**SUBDIVISION COMMITTEE
METROPOLITAN AREA PLANNING COMMISSION**

**STAFF REPORT
(Preliminary Plat)**

CASE NUMBER: S/D 98-110 - WESTPORT INDUSTRIAL PARK 7TH ADDITION

STAFF REPORT
(Final Plat, Preliminary Plat Approved 12/10/98)

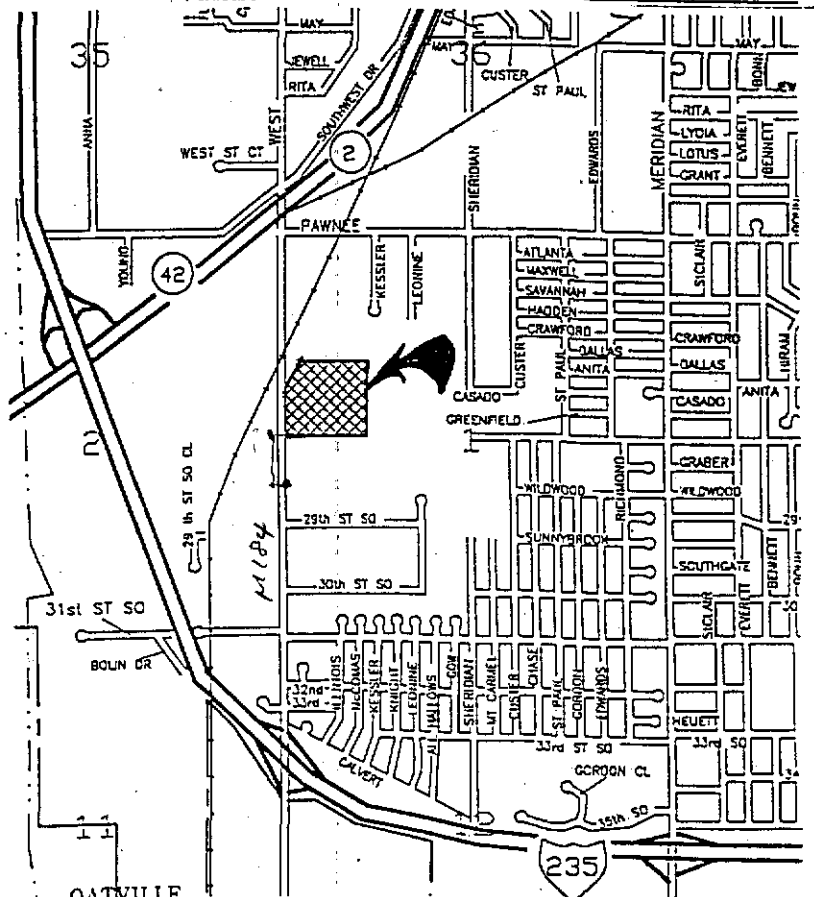
- A. The applicant shall guarantee the extension of City water and sanitary sewer. City Engineering needs to verify if any other additional guarantees are required.

- C. City Engineering needs to comment on the status of the applicant's drainage concept.
- D. The final plat needs to denote the dedication of access controls along West Street and reference the access controls in the plat's text. The applicant shall guarantee the closure of any driveway openings being located in areas of complete access control or that exceed the number of allowed openings.

- E. If any of this site's drainage is directed onto the adjacent railroad right-of-way, a letter shall be provided from that railroad indicating their willingness to accept such drainage.

- G. The platted building setback may be reduced to 20 feet; the requirement for the LI, Limited Industrial district.
- H. Traffic Engineering needs to comment on the need for improvements to West Street.

- I. The applicant shall guarantee the paving of the proposed interior street.
- J. City Fire Department shall comment on the street name.

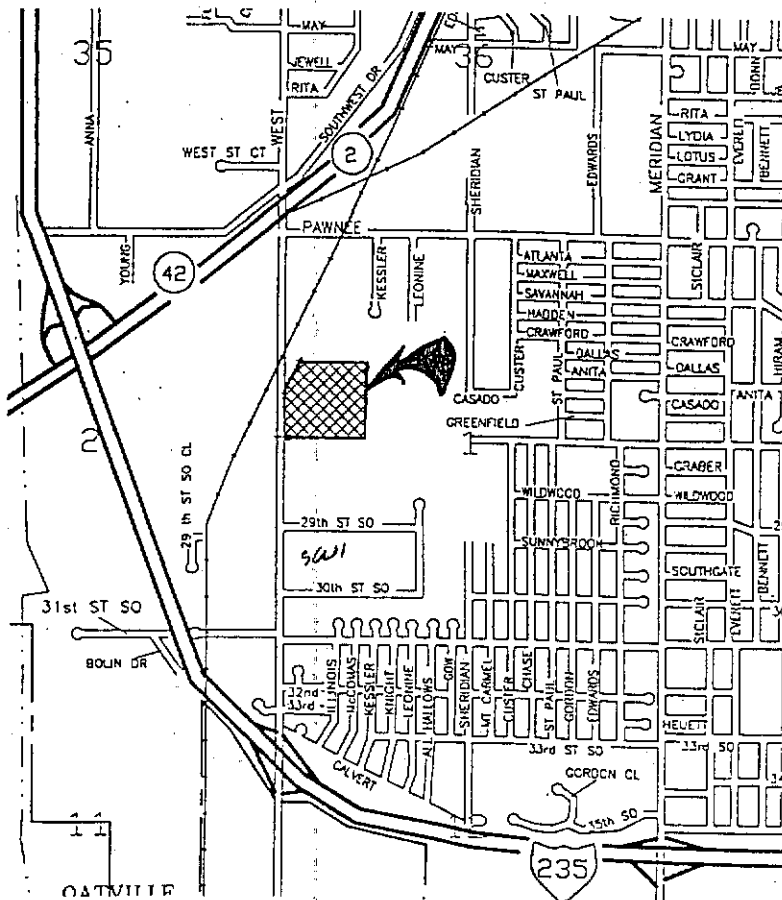
- A. The applicant shall guarantee the extension of City water and sanitary sewer. City Engineering needs to verify if any other additional guarantees are required. A sanitary sewer layout is requested.

- C. City Engineering needs to comment on the status of the applicant's drainage plan. The drainage plan needs to be submitted.
- D. The applicant shall guarantee the closure of any driveway openings being located in areas of complete access control or that exceed the number of allowed openings.

- G. The applicant shall guarantee the paving of the proposed interior street.
- H. City Fire Department shall comment on the street name. West Street Court shall be renamed West Court.

- Q. The representatives from the utility companies should be prepared to comment on the need for any additional utility easements to be platted on this property. **KGE has requested additional easements which have been denoted on the final plat.**

The final plat has included the requested street name change.
- I. The MAPC signature block needs to identify William M. Johnson as Chairman.
- J. The applicant shall install or guarantee the installation of all utilities and facilities which are applicable and described in Article 8 of the MAPC Subdivision Regulations. (Water service and fire hydrants required by Article 8 for fire protection shall be as per the direction and approval of the Chief of the Fire Department.)
- K. The applicant's engineer is advised that the Register of Deeds is requiring the name(s) of the notary public, who acknowledges the signatures on this plat, to be printed beneath the notary's signature.
